# UNITED STATES PATENT AND TRADEMARK OFFICE

10/728,892

<b>Office Action Summary</b>	<b>Application No.</b> 10/728,892	<b>Applicant(s)</b> KANG ET AL.	
	<b>Examiner</b> MARIA J. LAIOS	<b>Art Unit</b> 1795

## DETAILED ACTION

FIG. 28

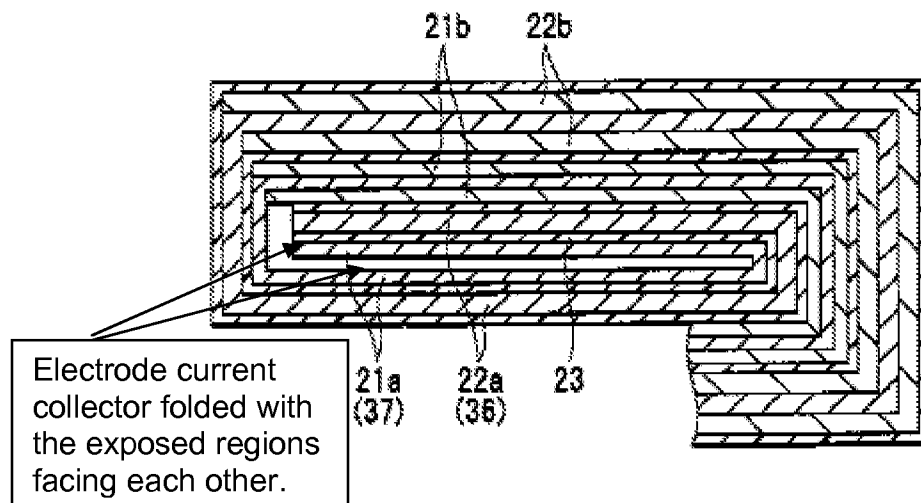
With respect to claims 5 and 12, Shibamoto further discloses the current collector (21a) is folded in upon itself such that any burrs that occurred from the manufacturing process will come in contact with the same material (Figure 28).

With respect to claims 21-24, Shibamoto discloses the folded portion is provided on the cathode where the uncoated portions are formed on both sides (37, double sided exposed portion) of the electrode plate and the exposed portions face each other (as seen in Figure 28 above).
